**Sent:** Monday, 22 October 2018 11:44 AM  
**To:** Clair Morrison  
**Subject:** 21 Vincent st, MT Lawley-response to advertising comments

SUN STUDY - FOR OVERSHADOWING  
 @ 12 noon  
 June 21.

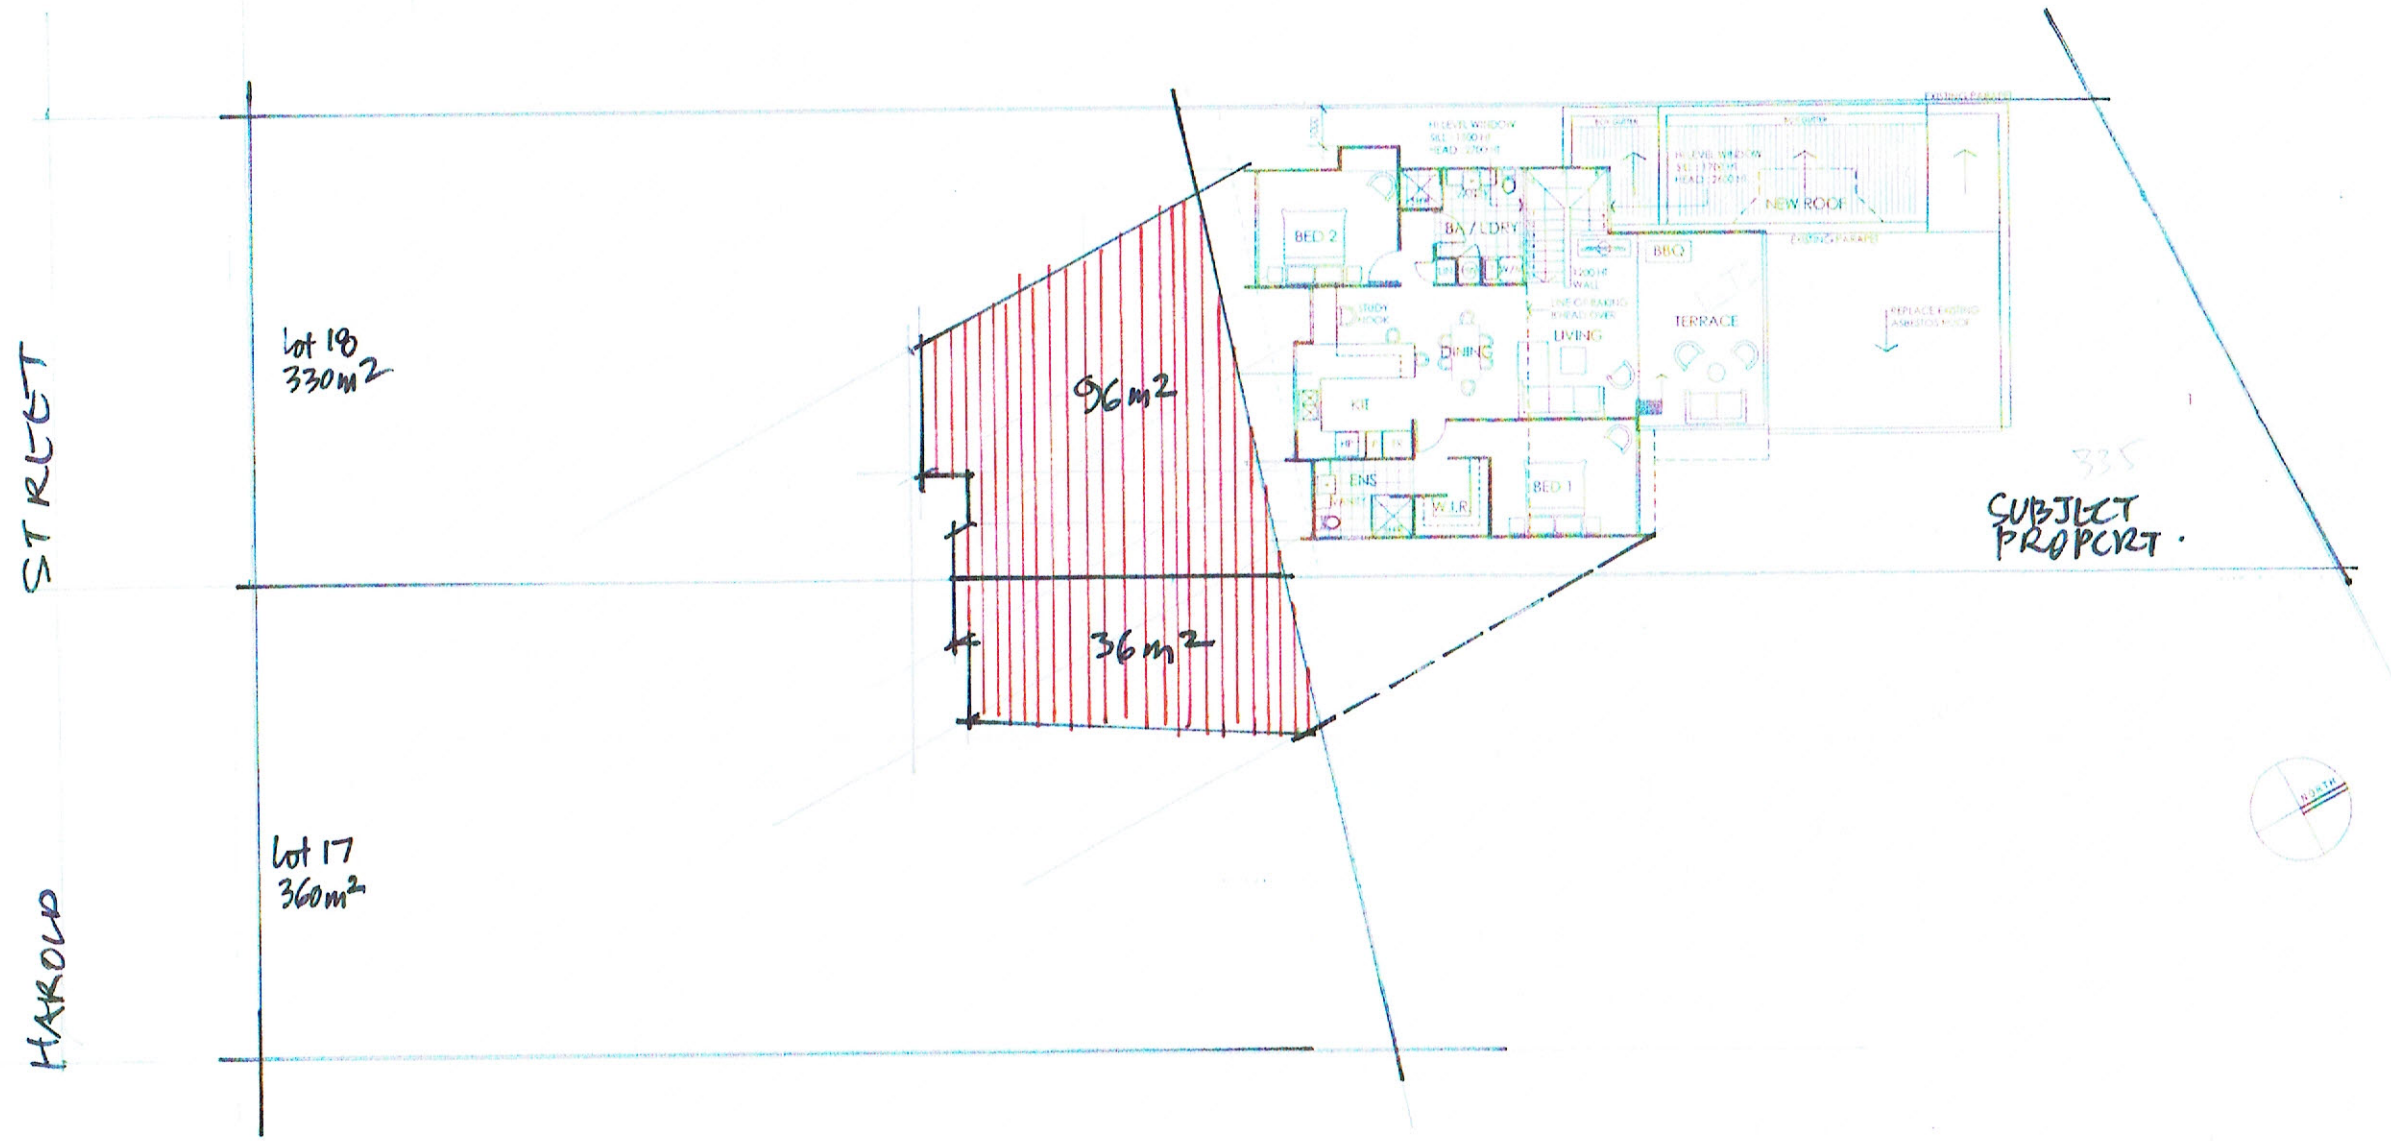
Issue: Overshadowing 1. Concern overshadowing will impact the use and amenity of adjoining outdoor living areas
Issue: Damage to adjacent lots 2. Concern over potential damage to dividing fences given the setbacks are extremely close to the lot boundaries
Issue: Dividing fences 3. Concern over the loss of privacy should the dividing fences be removed

**With regards to item 1 above**, please find attached a diagram of an overshadowing study (PDF 1) based on 21<sup>st</sup> June. Both 2 properties on the southern side of our property are NOT at all affected by the overshadowing requirements as detailed in the R-Codes and as indicated on the attached drawing.

Lot 18 - site area - 330m<sup>2</sup>  
 - max permissible - 165m<sup>2</sup> (50%)  
 - Actual - 96m<sup>2</sup> (29%)

Lot 17 - site area - 360m<sup>2</sup>  
 - max permissible - 180m<sup>2</sup> (50%)  
 - Actual - 36m<sup>2</sup> (10%)
